## HEARING OFFICER'S REPORT

**RE:** On-Site Wastewater Treatment and Disposal System Operations Permit Application of Allen Harim Foods, LLC ("Allen Harim") to treat poultry processing wastewater at its Harbeson Processing Facility located in Harbeson, Delaware.

**RE:** **Technical Response Memorandum - Response to Comments Received during the Public Comment Period and during the August 21, 2019 Public Hearing (Docket # 2019-P-W-0016) on the On-Site Wastewater Treatment and Disposal System Operations Permit Applications for the Allen Harim Harbeson Processing Facility and the Artesian Northern Sussex Regional Water Recharge Facility (ANSRWRF) near Milton, Delaware**

# **ANSRWRF Phase 1** **Surface Water Monitoring Plan**

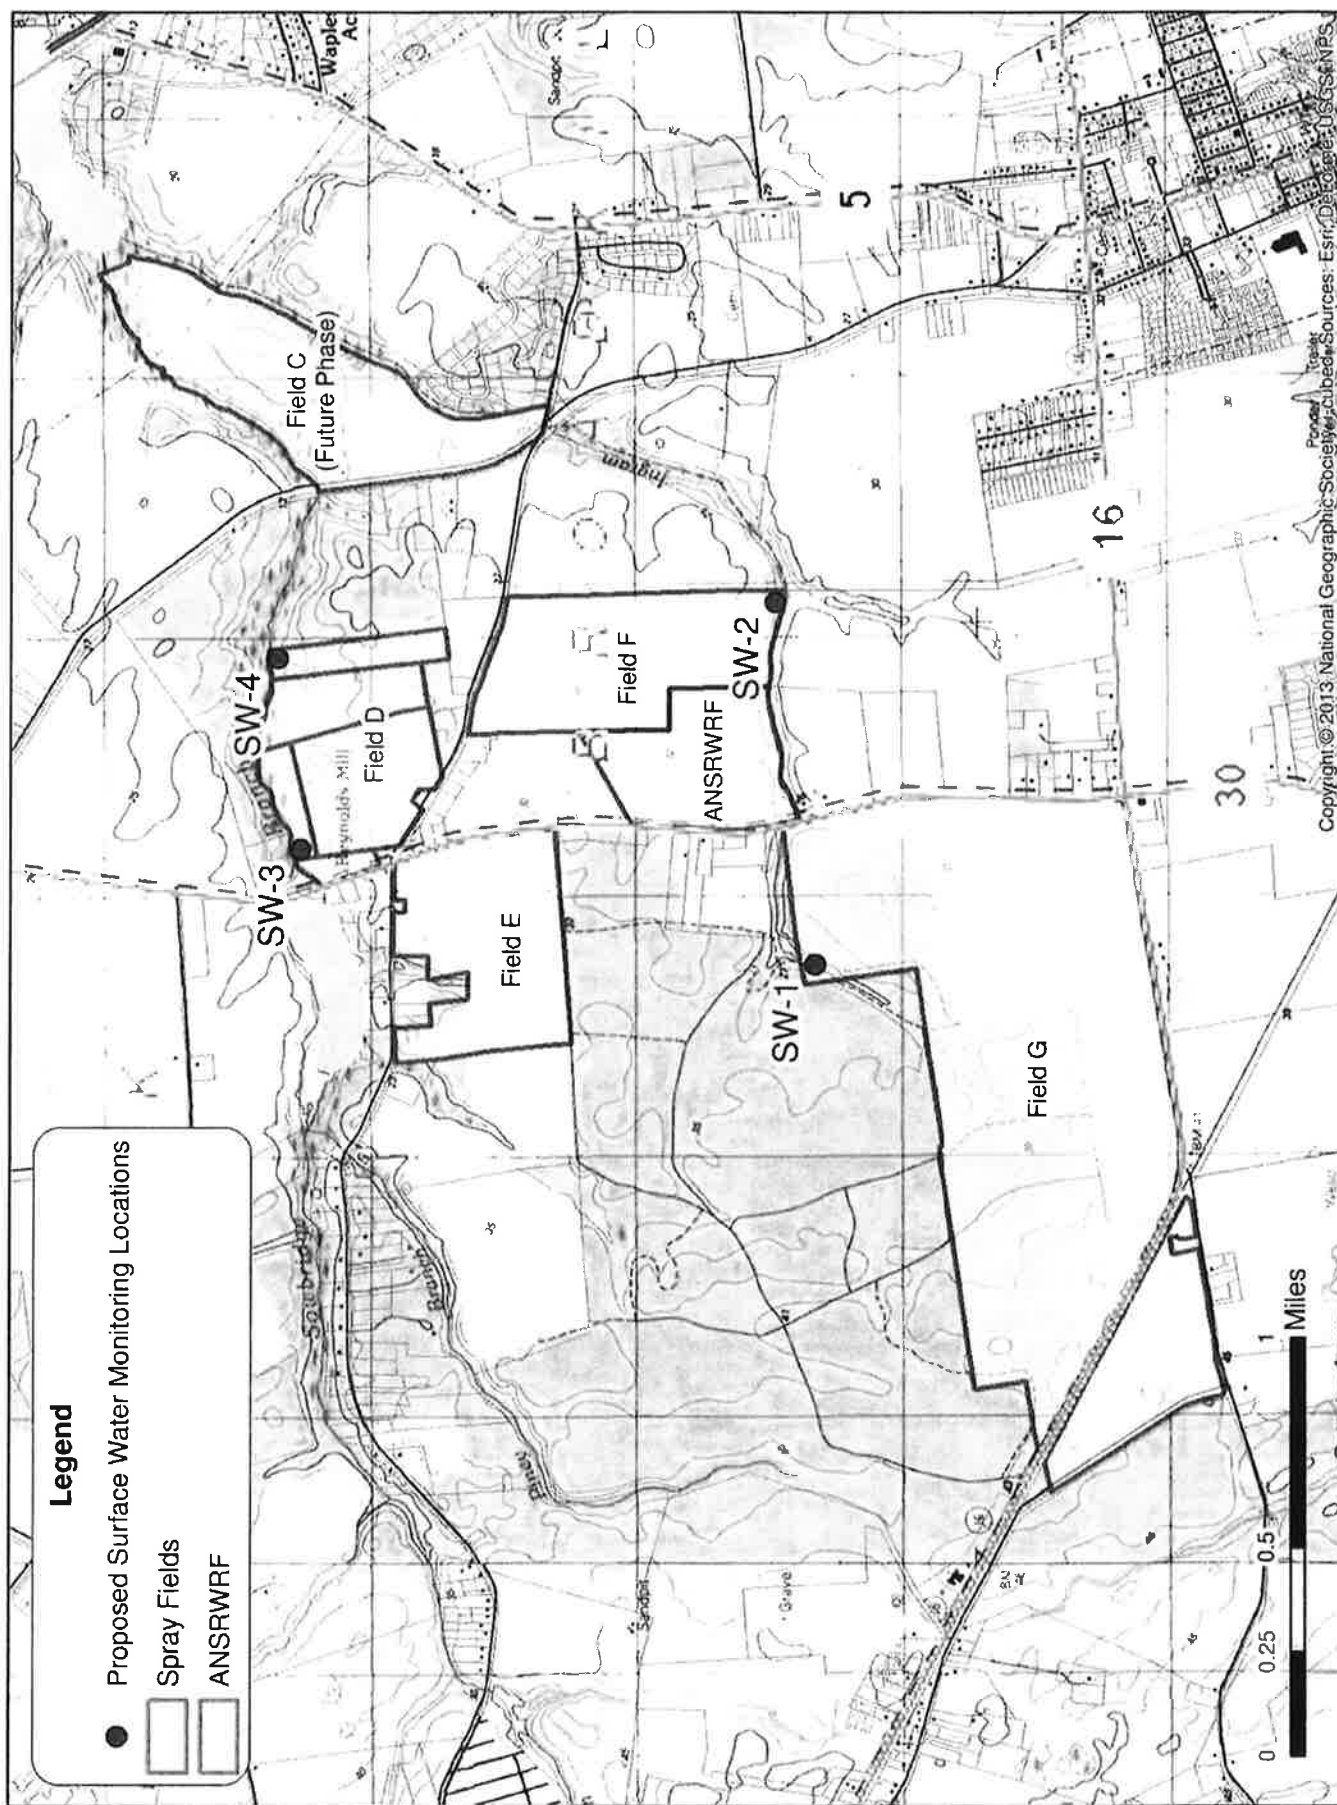
- c. Submit a surface water monitoring plan that includes a map with both the water bodies and proposed monitoring points depicted and labeled. See the approximately six waterbodies/tributaries adjacent to spray irrigation fields in Figure 3-7 of the DDR. [Response 3]

- b. The water body shown adjacent to Field E in Figure 3-7 is the 100-year flood extents of Reynolds Pond. Under normal conditions the water body extents are not adjacent to the spray fields. Therefore no surface water monitoring is proposed.

**ARTESIAN NORTHERN SUSSEX REGIONAL  
 WATER RECHARGE FACILITY (ANSRWF)  
 SPRAY IRRIGATION SYSTEM  
 SITE PLAN - FIELD G**

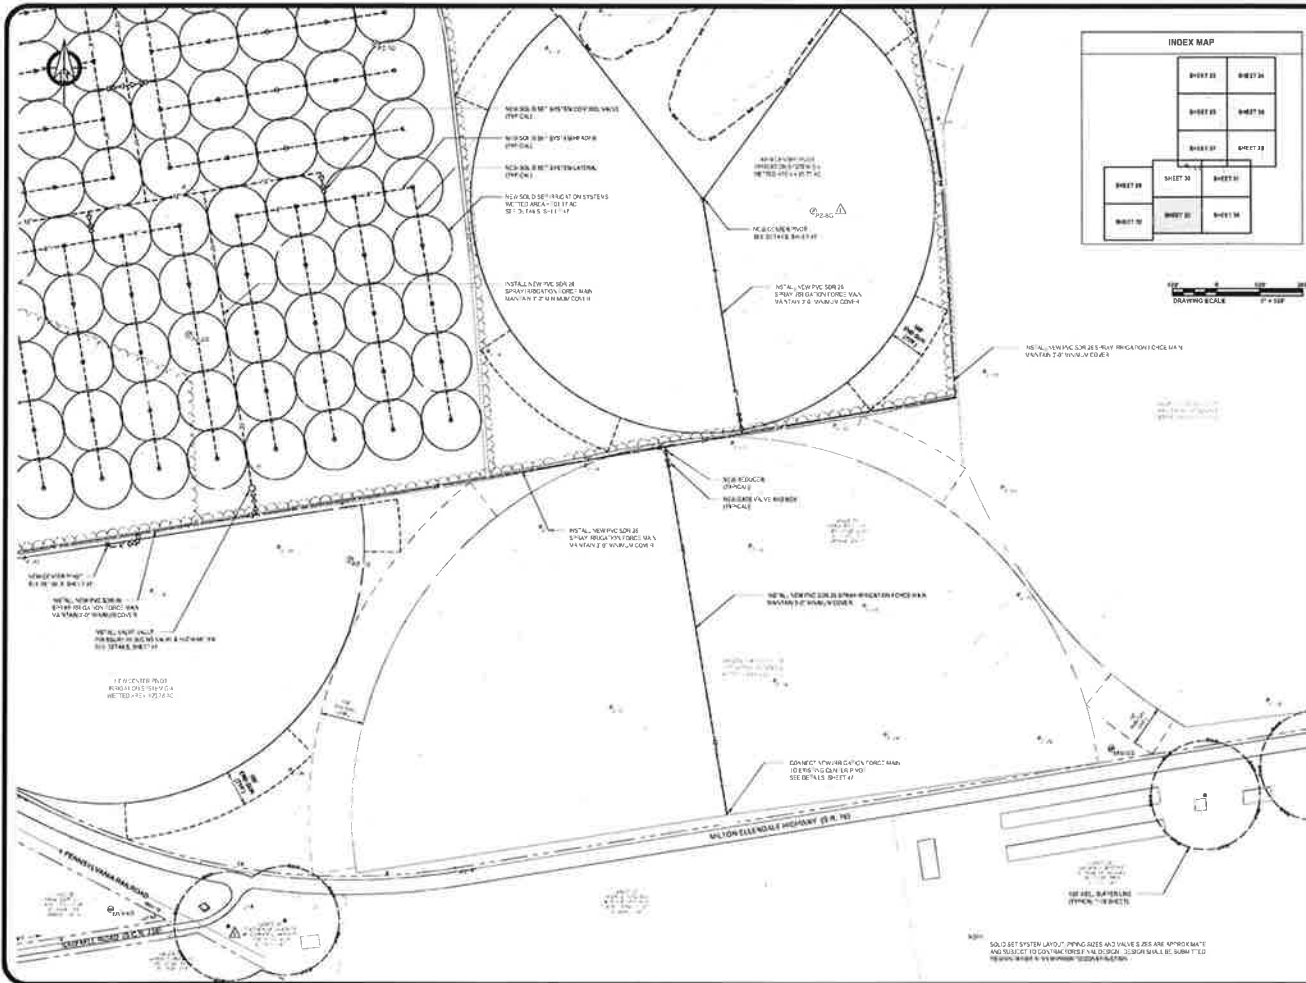
- vi. In accordance with DNREC Hydrogeologic review dated March 25, 2010, the Permittee shall install another permanent Observation Well (OW) in the area on field G between groundwater contours 31 – 32 in the location where the mounded average seasonal-high water table is predicted to lie as close as 0- 2' below the ground surface. When referring to the location for the additional OW, the Permittee should utilize Artesian's Consulting Engineers, Inc. large fold out map (Sheet No.1) of Artesian's March 3, 2010 document submitted to the DNREC Groundwater Protection Branch entitled, "ANSRWRF DDR Hydrogeological Appendix Response to Groundwater Protection Branch Memorandum March 3, 2010". [Response 8]

6. Hydro Review (Blair Venables, 7/25/2017)
- a. Add an additional Observation Well to the wet spot of Field G at the 32' elevation contour approximately 320' east of the new center pivot on Sheet 33. [Response 8]

8. Observation Wells [1.d.vi, 1.d.vii, 6.a]
- a. A new Observation Well (Piezometer) PZ-8G has been added to the wet spot on Field G, at the 32' elevation contour. See the updated Sheet 33.

Figure 1

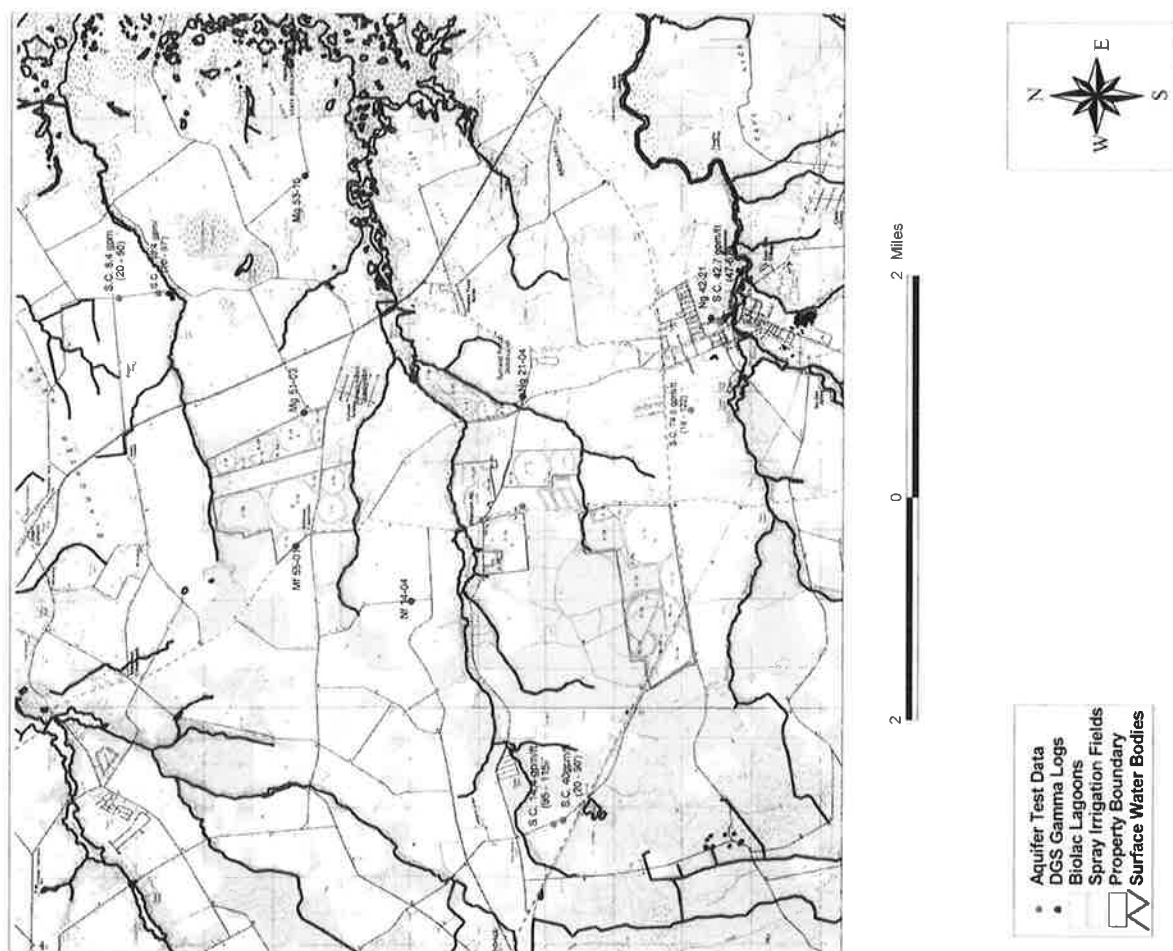
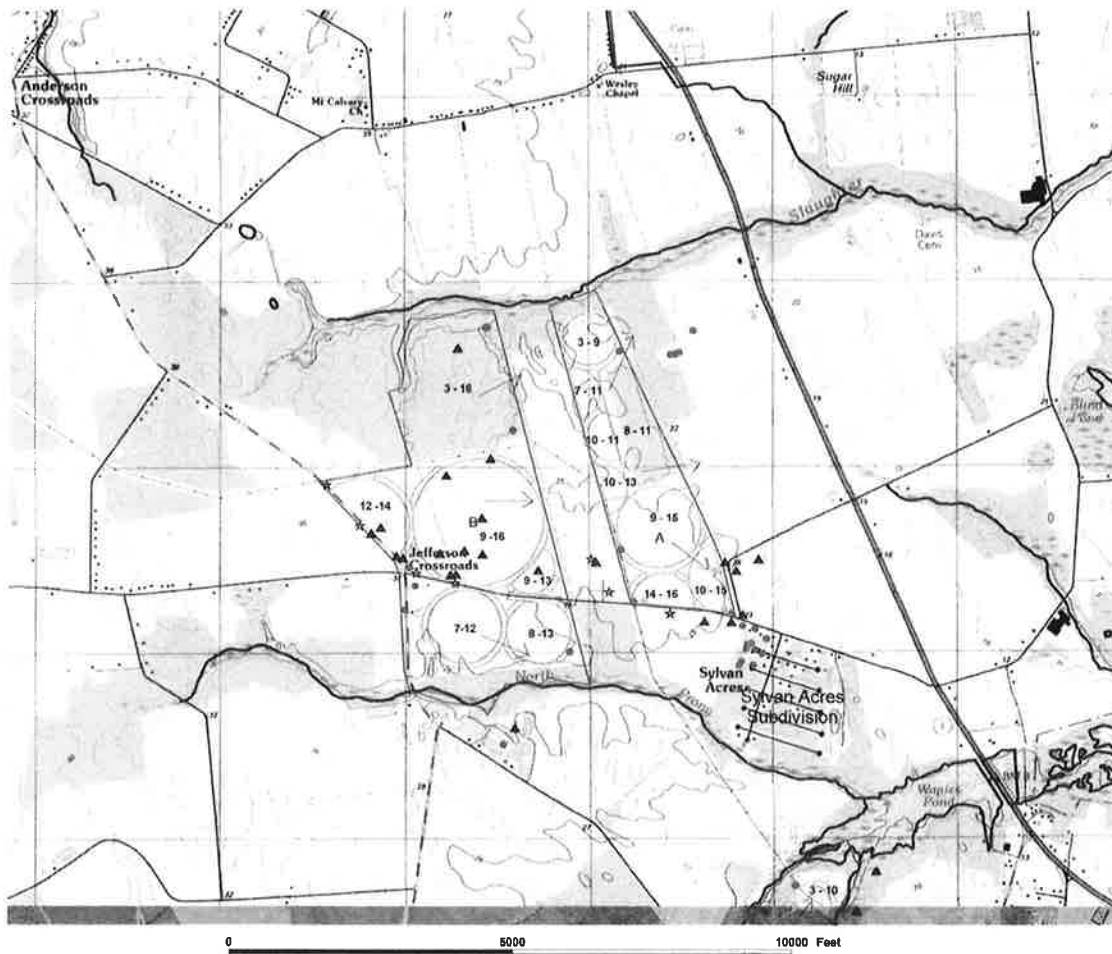
- Install an upgradient MW in field B in the location indicated on attached figure 2B.
  - Install an additional MW at field E to monitor groundwater flowing towards 1 off-site domestic well located to the north (see figure 2B for well location).

- Install an additional MW at field F to monitor groundwater possibly flowing towards 3 off-site domestic wells located to the north (see figure 2B for well location).

- Install two additional MWs at field G. One well is needed to monitor groundwater impacts moving towards 6 off-site domestic wells lying east of field G. Another well is needed to monitor the groundwater flowing towards 4 off-site domestic wells located south of the southwestern portion of field G (see figure 2B for well locations).

- Install new MWs in the locations indicated on attached figures 2A and 2B provided that the new determinations of groundwater flow are similar to previous directions determined for the sites.
- Provide a MW plan for infield MWs that must be installed at each of the 7 proposed spray fields as required by the land treatment regulations. In addition, an upgradient MW must be sited for the wastewater storage lagoons. The locations for all the required MWs and all of the consultants proposed MWs must be shown on maps provided to the Department. Corresponding well labels must also be provided on the map. The Department must approve of the plan prior to MW installation.
